From: Belton, Moni [moni_belton@fws.gov]
Sent: Thursday, March 14, 2013 5:00 PM
To: Balsam, Briana
Subject: South Texas NRC informal consultation
Attachments: Atch 1 Houston Toad Survey_Requirements.pdf; Atch 3_BMP for river, streams or tributary impacts.pdf; Figure 1 Whooping Crane Corridor.pdf; Atch 2_FWS June_02_2011_letter.pdf

Subject: ER 12-0888, Review of the Generic Draft Environmental Impact Statement (GDEIS) for License Renewal of Nuclear Plants Supplement 48 regarding South Texas, Units 1 and 2.

Figure 1. Whooping Crane Migratory Corridor

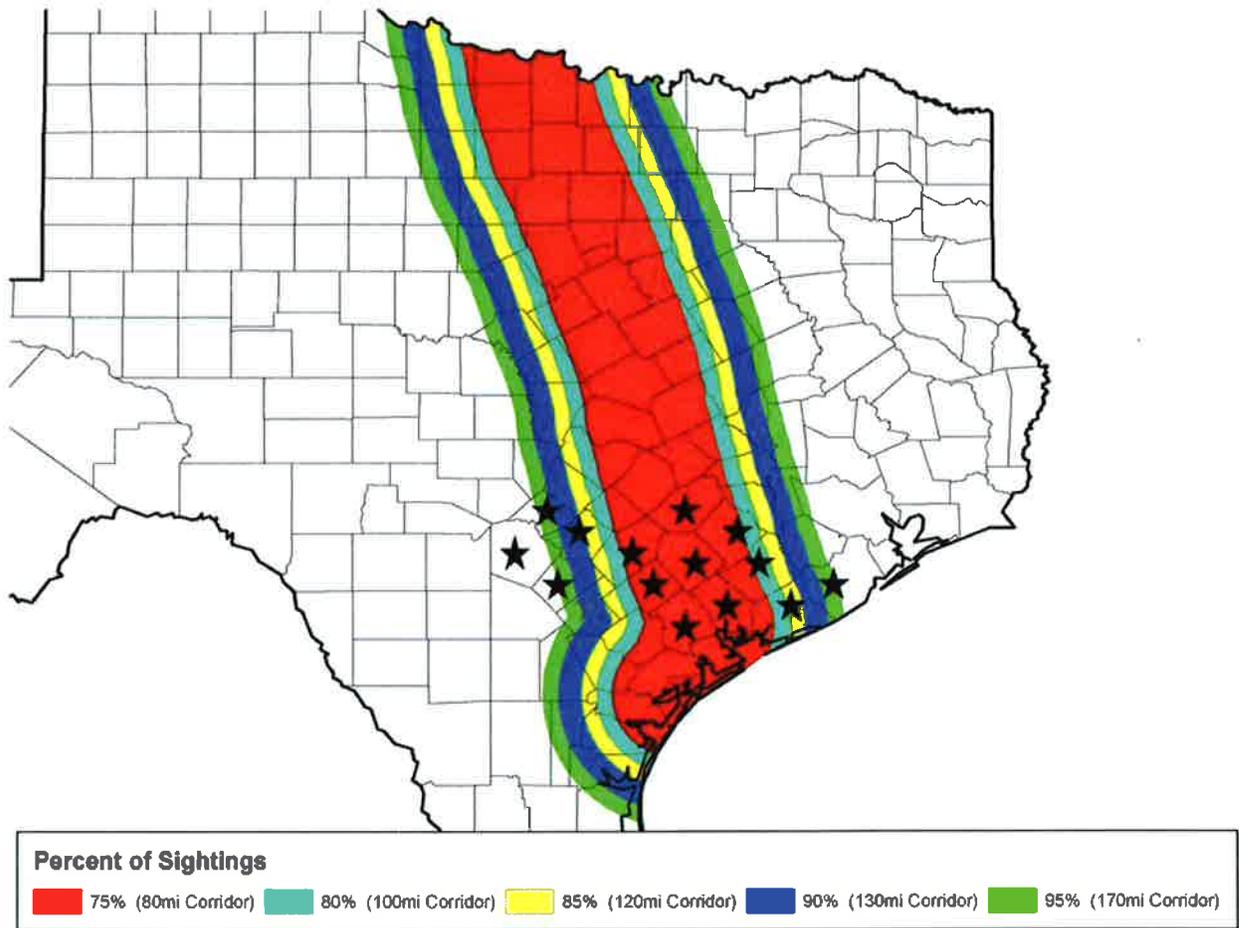
- Schedule work, within the Whooping Crane migration corridor, outside Whooping Crane migrating seasons (normally between March 25 and April 15). See Figure 1, Whooping Crane migration corridor.
 - Consider additional measures, such as adding bird diverters, to reduce impacts along transmission lines.
 - If it is necessary to perform maintenance work during the migrating season biological monitors may be recommended.
 - If using equipment over 15 ft high, lower overnight or mark with diverters.
 - Educate staff on the Whooping Crane, status, identification, and habitats.
 - In any areas where maintenance is being conducted and Whooping Cranes are sited within 1000 feet cease work and notify the Service of the occurrence.
- Please refer to the additional Whooping Crane guidance in the Service's June 2, 2011 letter (attachment 2, Appendix D in the GDEIS).

All 15 counties are within the whooping crane migratory corridor and some are in the critical wintering grounds of the endangered whooping crane (*Grus americana*) (see Figure 1). Whooping cranes use a variety of habitats including marsh, tidal flats, uplands, and barrier islands and roost in waters less than 10 inches. Whooping cranes usually arrive on the Texas coast between late-October and mid-November and spend almost six months on the wintering grounds. As spring approaches, they leave for the breeding grounds in Canada normally between March 25 and April 15 with the last birds usually gone by May 1st (occasional stragglers may stay into mid-May).
